345 kV LINE

STATION 211, WOBURN TO NATIONAL GRID WAKEFIELD SUBSTATION

Re: Constructability Review for Proposed 345kV Line, Plan and Profile Drawings 14-32

In accordance with our Agreement for Engineering Services, dated May 12, 2016, titled, Engineering Services for the Constructability Review of Proposed Station 211, Woburn to National Grid Wakefield Substation 345kV Line, Weston & Sampson is pleased to present our findings. Our review is based on Black & Veatch Corporation's plans dated September 08, 2015 and titled "Station 211, Woburn to National Grid Wakefield Substation 345kV Line", stamped "Issued to Town of Winchester on" October 27, 2015" (the "Plans"). Specifically, our review will be limited to Drawing Nos. 14 – 32 (19 plan sheets).

CROSS STREET — PLAN 13 OF 83

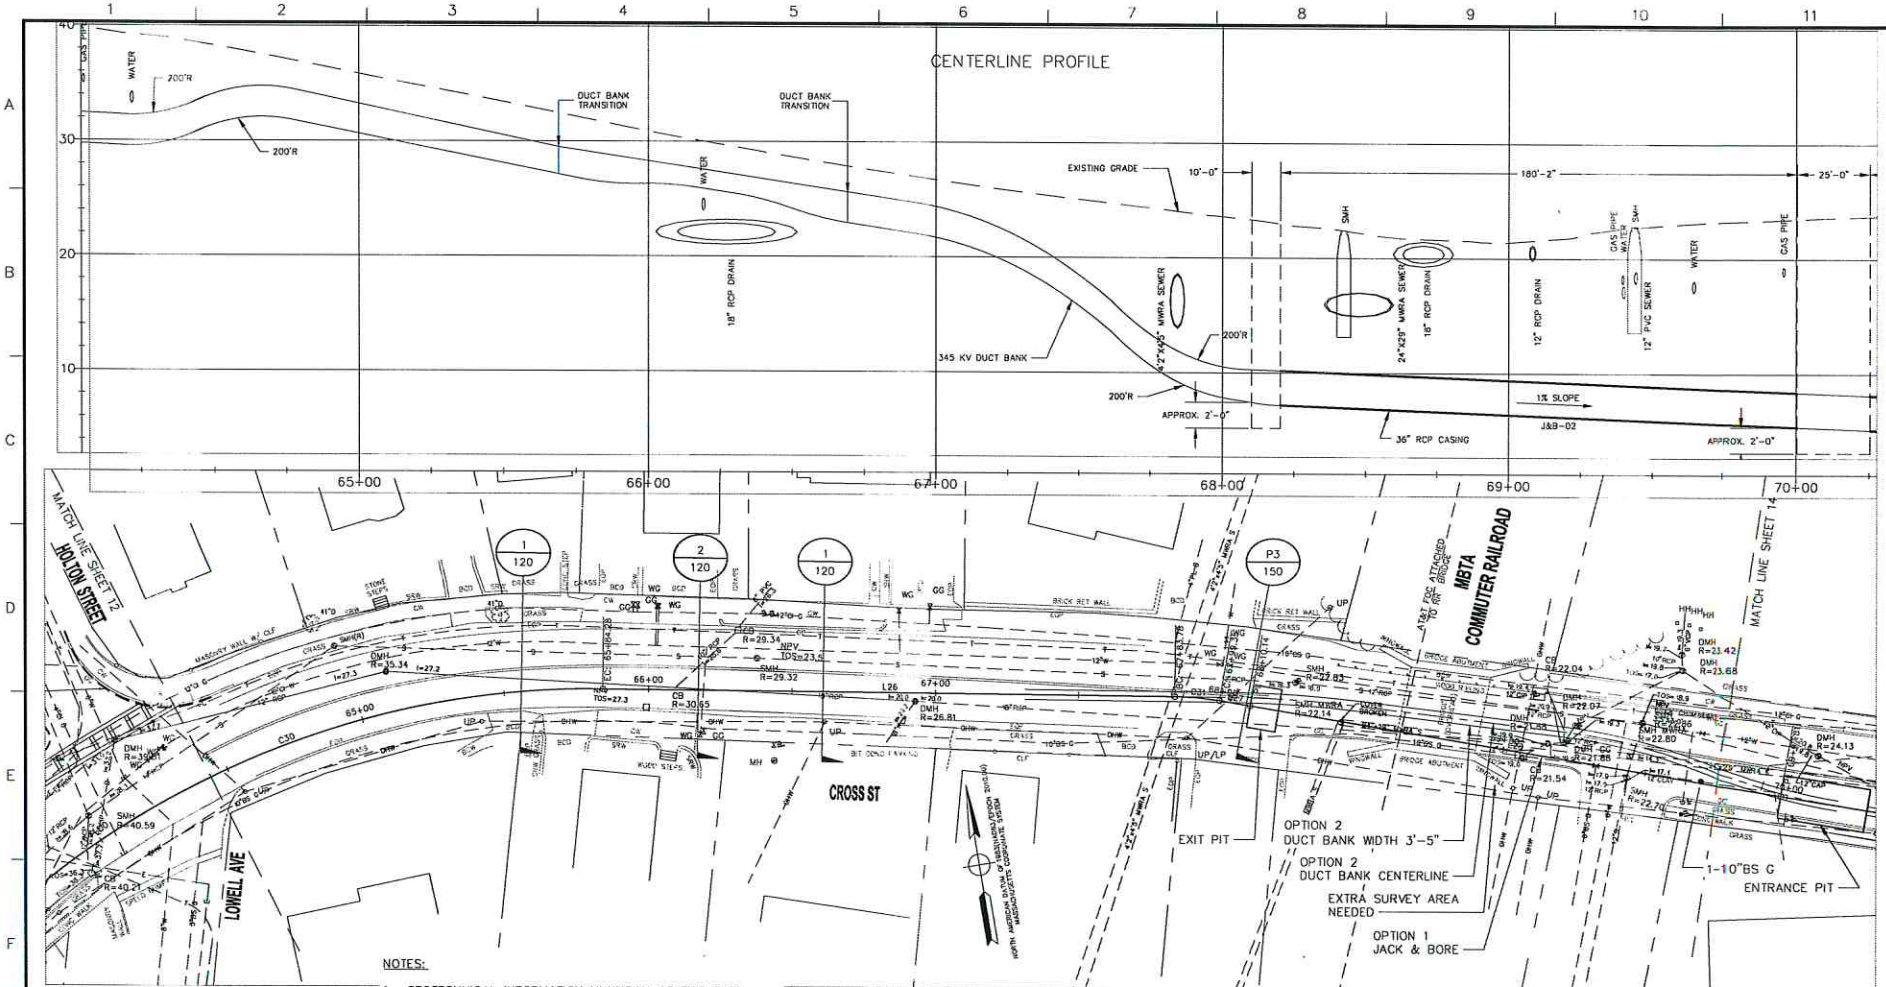
- Layout of intermediate jacking pit at RR/river crossing along Cross Street and jacking pits at river crossing along Washington Street provide inadequate safe clearances for temporary jersey barrier/CLF perimeter and minimum lane width for alternating traffic. Edge of excavation to existing curb line at the intermediate pit for the combined RR and river crossing on Cross Street measures 17 feet. Similar clearances for the two jacking pits on Washington Street measure 11 feet. The depth and proximity of the pits to an active travel lane presents a severe hazard. Optional detour routes for Cross Street are restricted by limited proximity of RR grade crossings/overpasses and/or overhead clearances at underpasses.

Jack and bore installations on Cross Street and Washington Street highlight the lack of a comprehensive Traffic Management Plan. Coordination and development of a workable plan, including temporary detour routes, is vital for mitigation of construction phase impacts. The plan should be made part of the design documents.
